Fwd: Dog Hole Capping, As built Diagram, Horizon Mine Permit C/007/0020

HORIZON MINE - "DOG HOLE" PORTAL CLOSURE
UDOGM PERMIT C/007/0020 MSHA I.D. 42-02074
FEDERAL COAL LEASE 1111-74804

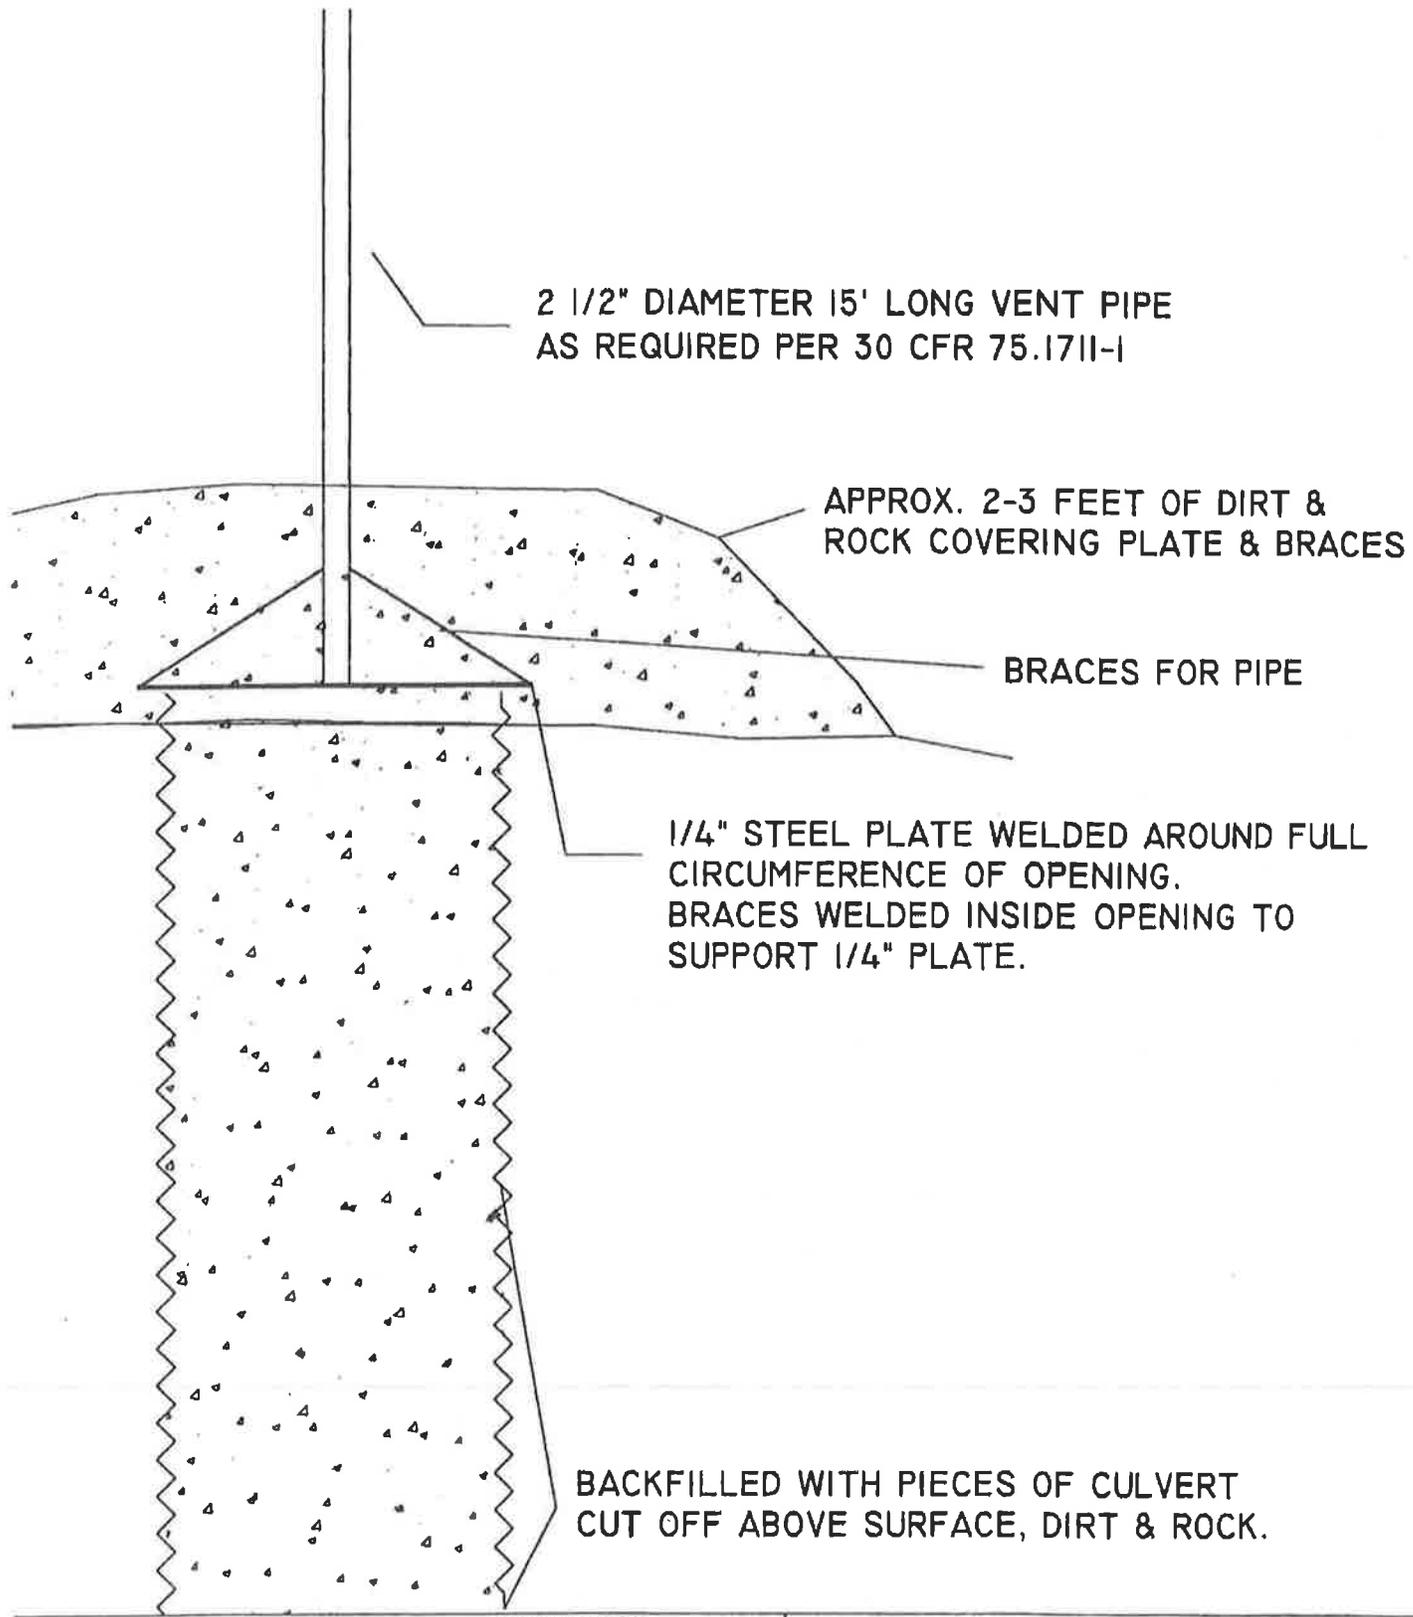
I have looked at the "as-built" diagram of the dog hole capping that you sent to us. Thank you for the diagram which is clear and describes the backfilling of the hole, however, I am concerned that the submittal does not satisfy the BLM's closure requirements. Please refer to the BLM letter dated September 24, 2015 which is attached. The "as-built diagram should be accompanied by a signed and notarized affidavit explaining the construction process, design, and materials used in the backfill. The letter also discusses the closure of the three other main portals. Again, it seems that we have a disconnect between what the BLM is expecting and your current mine closure plan. The BLM has indicated that at least 25 feet of backfill is required in front of the seals. Your plan only talks about 20 feet. The BLM has stated that at least one P-trap should be installed. Your plan does not discuss the installation of any P-traps. The BLM contemplates that there would be backfilling over the portals (to ensure 25 feet of backfill). Your plan states that backfill will only be to the mine opening.

I feel that it is important that we all understand what the sealing plan is for the mine. At this point, the plan is too vague and does not address the issues that were discussed in the September 14th meeting. Please provide a response that addresses these concerns. Thank You.
